Access Compliance Report

Public Rights-of-Way

(Curb Ramps)

Intersection ID: 11488	Main Street: N_CHURCH_ST	Cross Street: W_12TH_ST	Location: S
ADA ID: F1F7133E1BFB	Ramp Type: BlendTrans1	Initial Pass/Fail: Fail	Overall Compliance: No
		Severity Score: 1.25

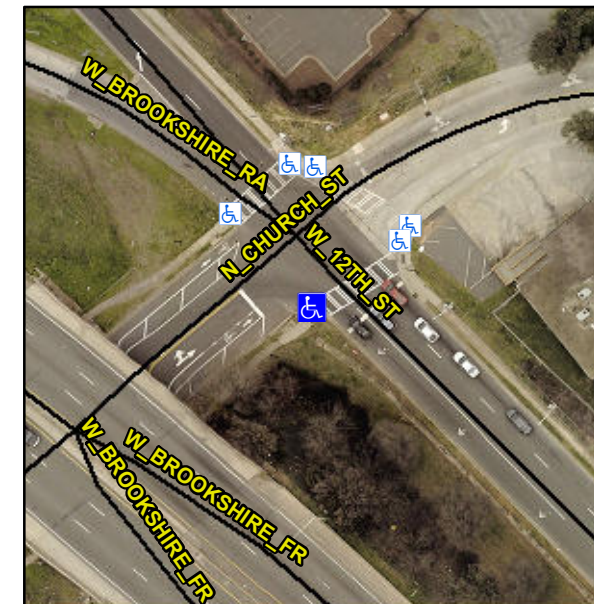
Compliance	Description	Data	Compliance	Description	Data
N/A	Ramp Length (in)	114.0	Yes	BlendTrans Slope (%)	2.0
Yes	Ramp Width (in)	58.0	Yes	BlendTrans XSlope (%)	2.4
N/A	Flare Type LT	N/A	N/A	Flare Type RT	N/A
N/A	Flare Slope LT (%)	N/A	N/A	Flare Slope RT (%)	N/A
N/A	Flare Traversable LT?	N/A	N/A	Flare Traversable RT?	N/A
N/A	Landing Length (in)	N/A	N/A	DWS Provided?	N/A
N/A	Landing Width (in)	N/A	N/A	DWS Contrast?	N/A
N/A	Landing Slope (%)	N/A	N/A	DWS Length (in)	N/A
N/A	Landing X Slope (%)	N/A	N/A	DWS Full Width?	N/A
N/A	Landing Curb? (Y/N)	N/A	N/A	DWS Offset (in)	N/A
N/A	Shared Landing?	N/A			
N/A	Gutter Ponding?	N/A	N/A	Gutter Slope (%)	N/A
N/A	Gutter Lip Ht (in)	N/A	N/A	Gutter X Slope (%)	N/A
N/A	Painted X Walk1?	Yes	N/A	Painted X Walk2?	N/A
	X Walk 1 Direction	To NE		X Walk 2 Direction	N/A
	X Walk 1 Width (in)	122.5		X Walk 2 Width (in)	N/A
	X Walk 1 Slope (%)	1.9		X Walk 2 Slope (%)	N/A
	X Walk 1 X Slope (%)	3.9		X Walk 2 X Slope (%)	N/A

N/A	Ramp inside XWalk1?	Yes	N/A	Ramp inside XWalk2?	N/A
	Road Slope (%)	3.9		Clear Space?	N/A
	Road X Slope (%)	1.9	N/A	Clear Space to XWalk (in)	N/A
N/A	Any Obstructions?	N/A	N/A	Storm Grate/Utility Hazard?	N/A
	Obstruction Type			Storm Grate/Utility Type	
		N/A			N/A
			Yes	Surface Condition? (G/P)	Good
			No	Curb Slope (%)	12.9

Remove & Replace Curb Ramp With Two New Directional Ramps or Equivalent.
